From: Henry Lister <halister@bellsouth.net>
Sent: Wednesday, October 11, 2023 2:58 PM
To: All Agenda Materials <allclerk@townofchapelhill.org>; Town Council <mayorandcouncil@townofchapelhill.org>
Subject: Hillmont materials for Town Council meeting 10/11

Traffic Concerns Regarding the Hillmont Proposal
Submitted by Henry Lister, supported by residents of Sherwood Forest
October 11, 2023

SUBJECT: Woodmont on NC 54 East Application for Master Land Use Plan
(File No. 9798-04-71-8729)

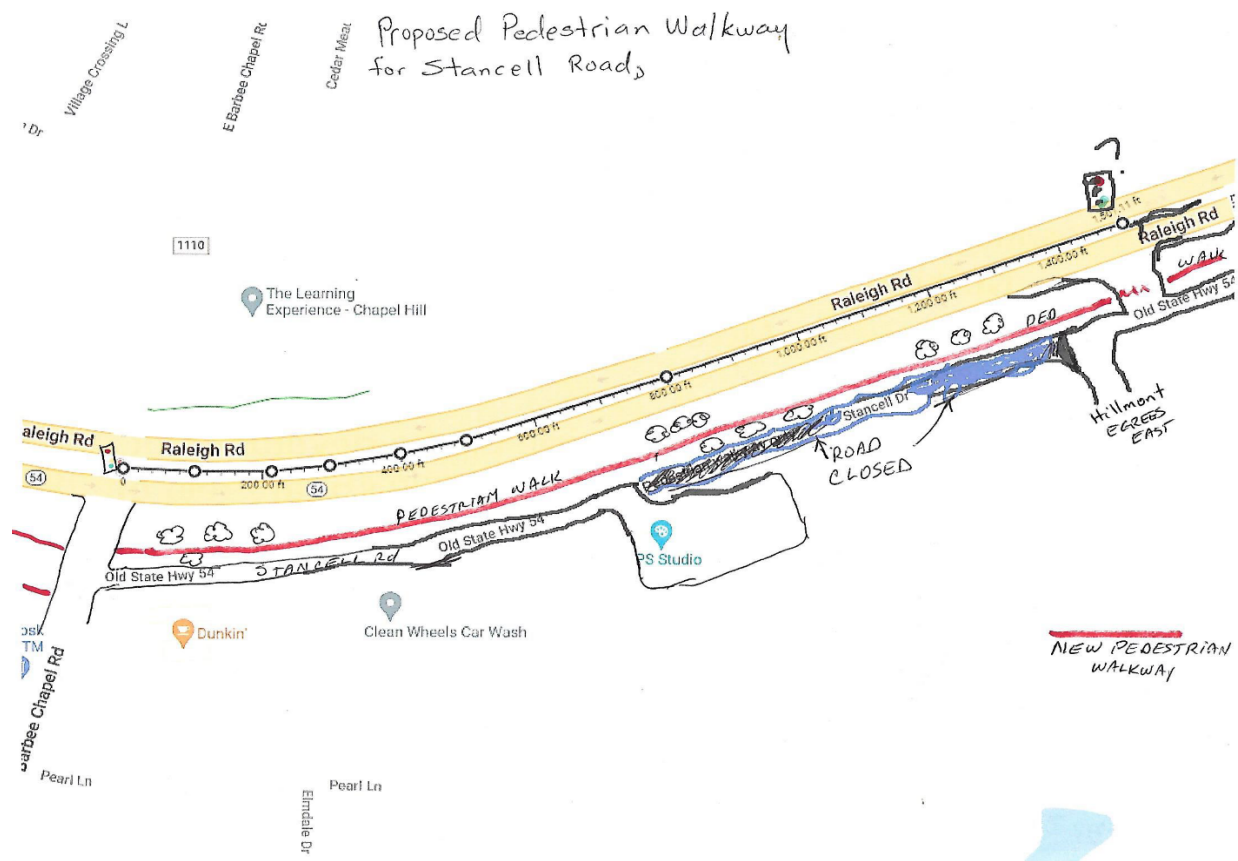
The proposed Hillmont development would contain a maximum of 500 units. A project of this size will generate over 3000 daily trips in and out of the development directly onto Stancell Road. When the previous project (Woodmont) was awarded an SUP, the staff at the Durham Planning Department (included in Council packet 10/11/23) provided a courtesy review of traffic issues. Item #2 stated that many of the recommended or required roadway improvements appear:

"impracticable [sic] or infeasible to construct, therefore we cannot provide final comments about the potential traffic impacts and needed mitigation improvements until NCDOT (Congestion Management and District Engineer) has completed their review of the TIA. Once NCDOT has completed their review of the TIA, we recommend a meeting be held with municipalities, NCDOT, and the applicant to determine the required roadway improvements."

Proposed Pedestrian Walkway for Stancell Roads

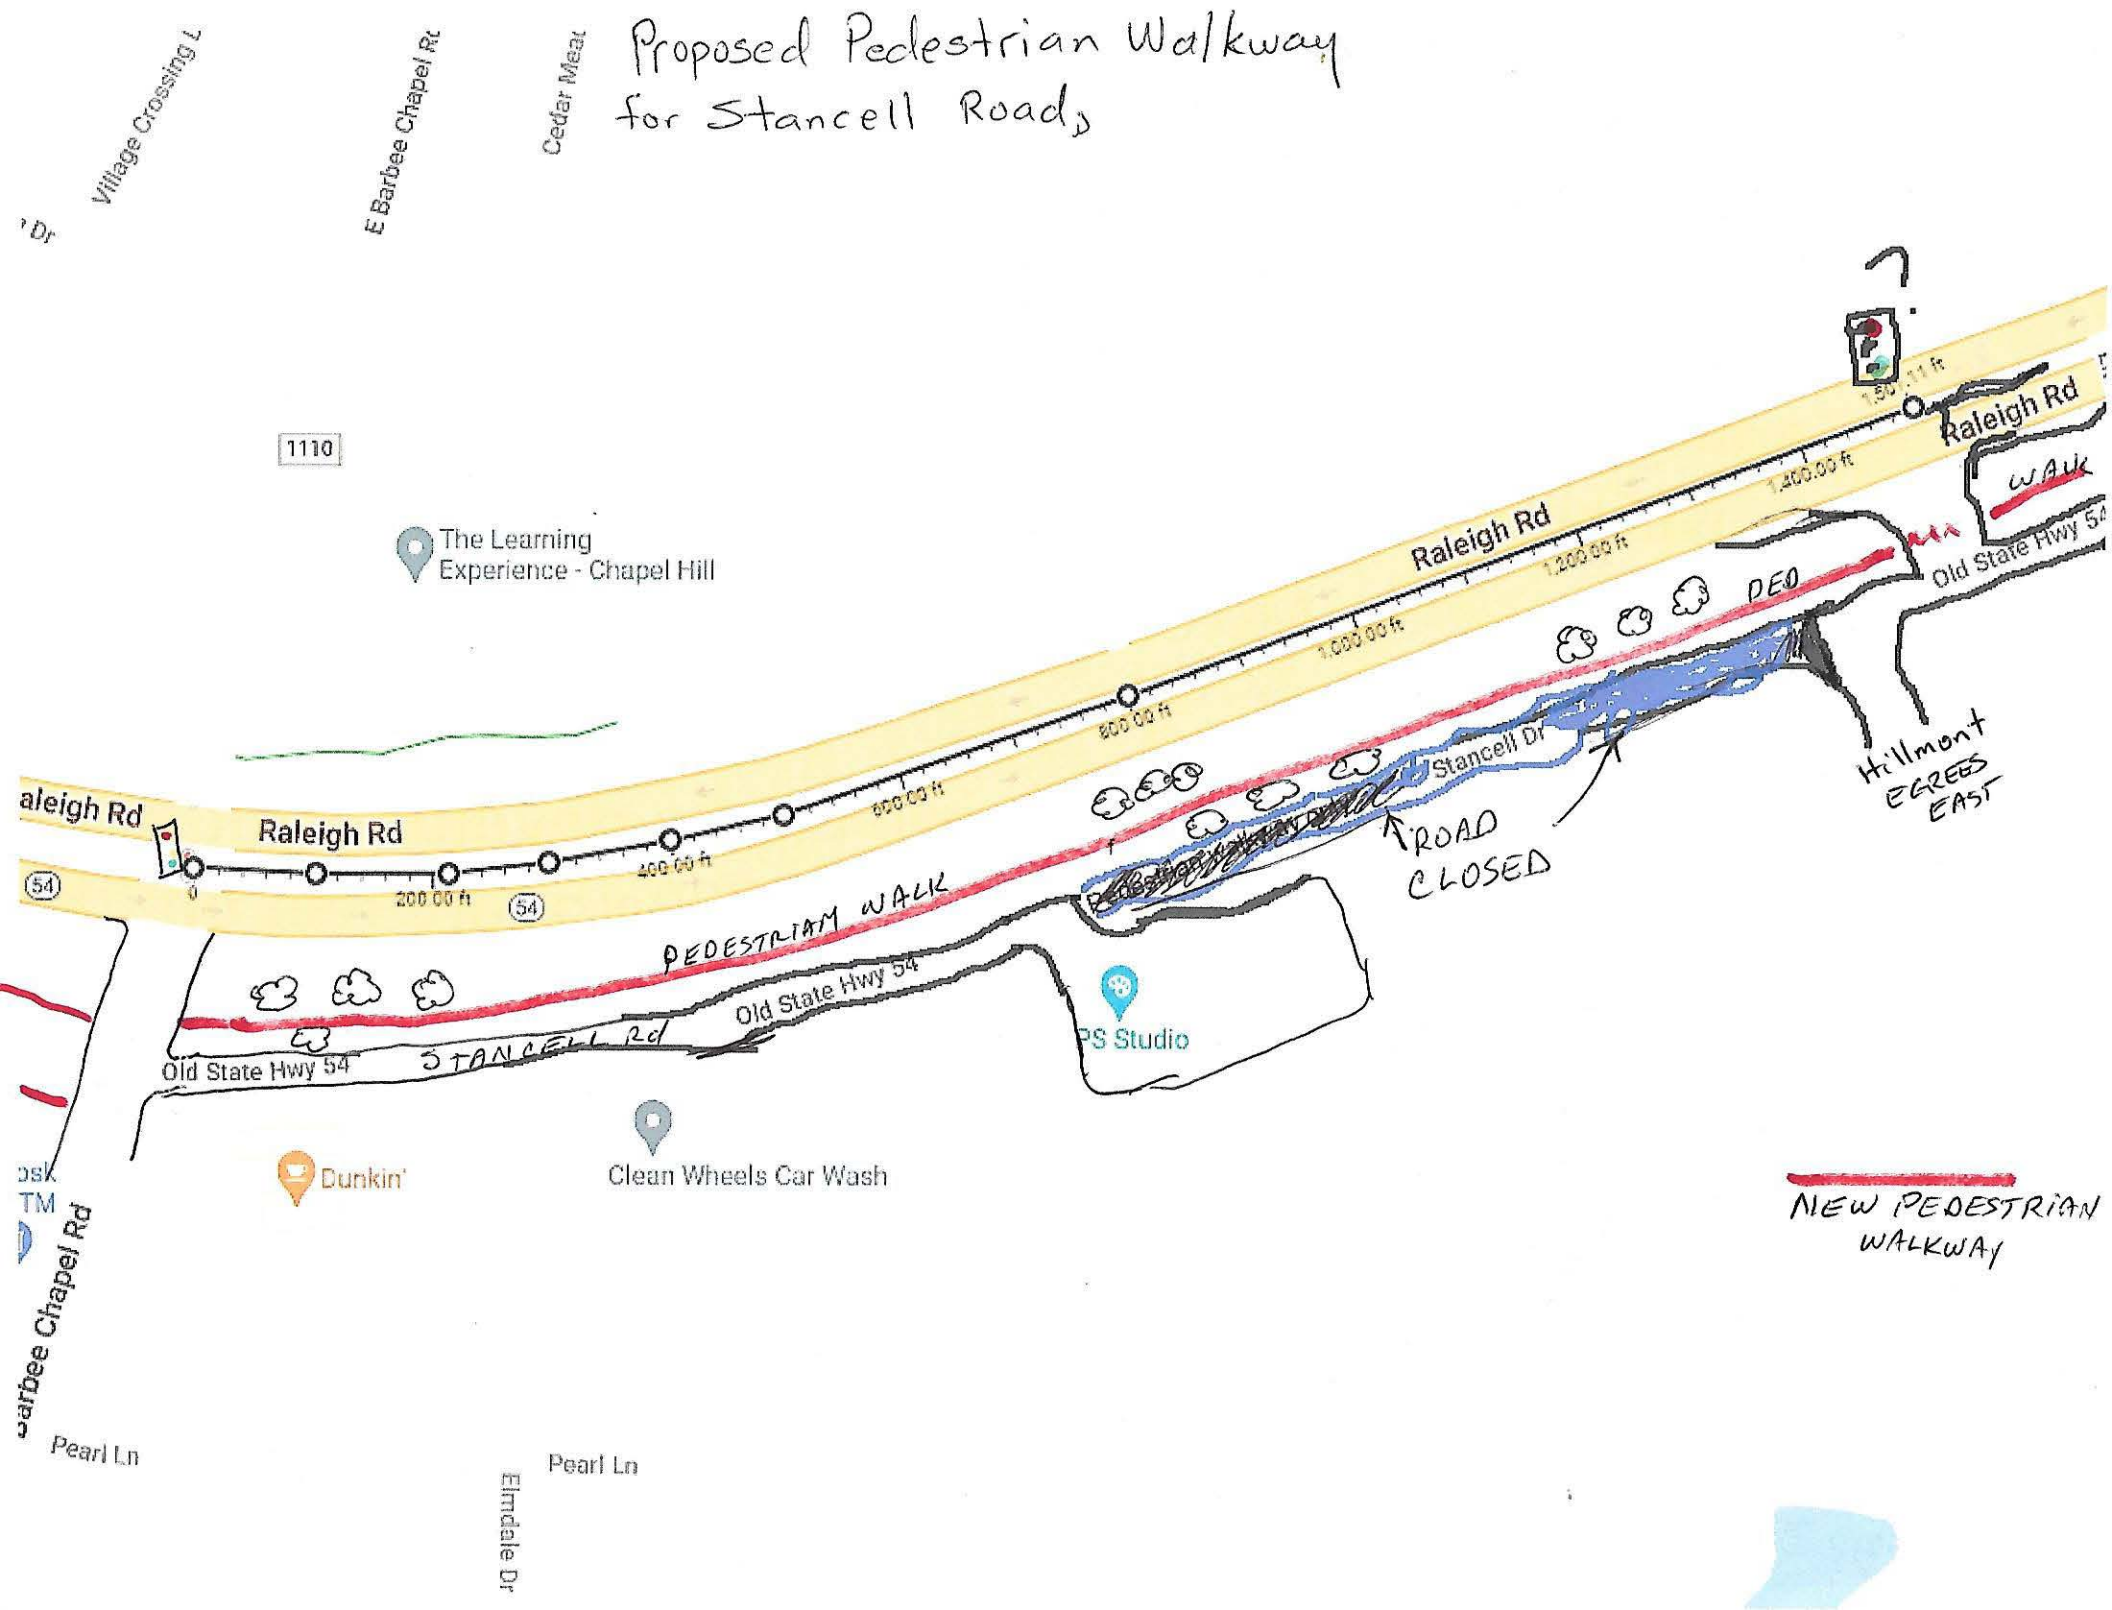
1. Close Stancell Road between the PhotoShop and the east egress proposed by Hillmont. Close Little John Road's access to NC-54, and create a new traffic lighted outlet onto NC-54 to accommodate Sherwood Forest and Hillmont traffic.
2. Create a pedestrian pathway through the verge between NC-54 and Stancell Road extending from Barbee Chapel Road to Downing Creek. This path would be 6-foot wide and landscaped like much of the path adjacent to the 54 East office buildings.

A suitable solution is to extend a path in the verge between NC54 and Stancell Road. This pathway could be landscaped and provide a much needed and safer pedestrian walkway to Downing Creek and Sherwood Forest. (See handout drawing, "Proposed Pedestrian Walkway for Stancell Road").
